CITY OF ALBUQUERQUE

**RE: Kirkpatrick Warehouse (File: C17D122)
Grading and Drainage Plan, Engineer's Stamp Date 2-5-15
Drainage Report, Engineer's Stamp dated 11-25-14**

RE: Revised Grading Plan (C-17D122)
Kirkpatrick Warehouse
Albuquerque, New Mexico

ENGINEER'S SEAL	TRACT B-1-A-5 CLIFFORD INDUSTRIAL PARK	DRAWN BY: JCG
	GRADING AND DRAINAGE PLAN	DATE 01-12-2015
	 <i>Rio Grande Engineering</i> 1500 CHERRY AVENUE, SE SUITE 100 ALBUQUERQUE, NEW MEXICO 87102-0695 (505) 872-0695	SHEET # 1 OF 1
2/5/15		JOB #
DAVID SOBOL P.E. #144522

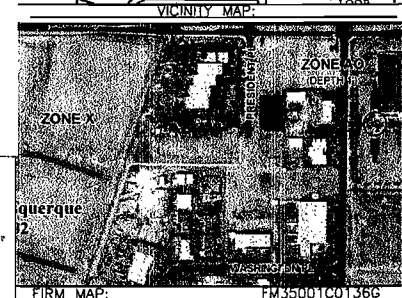
- Add rip-rap where the drainage channel along the south side discharges to the retention pond.
- Note that the fence is to be removed.
- Limit the diameter or size of any landscaping that is to be put within the channel so that the capacity of the channel is not reduced.

6"-8" FRACTURED ROCK OVER FILTER FABRIC PLANTING ALLOWED CHANNEL. SEE LANDSCAPE FOR LOCATION TYPE

1. ALL SPOT ELEVATIONS REPRESENT FLOWLINE ELEVATION UNLESS OTHERWISE NOTED.
2. TOPOGRAPHIC SURVEY INFORMATION SHOWN ON THIS PLAN WAS OBTAINED BY Christopher J. Delier, NMLS 7923
3. ONSITE CURB SHALL BE 6" UNLESS OTHERWISE NOTED
4. ALL POND SHALL BE LINED WITH 6-8" FRACTURED ROCK. LANDSCAPING SHALL BE INSTALLED WITHIN ROCK.
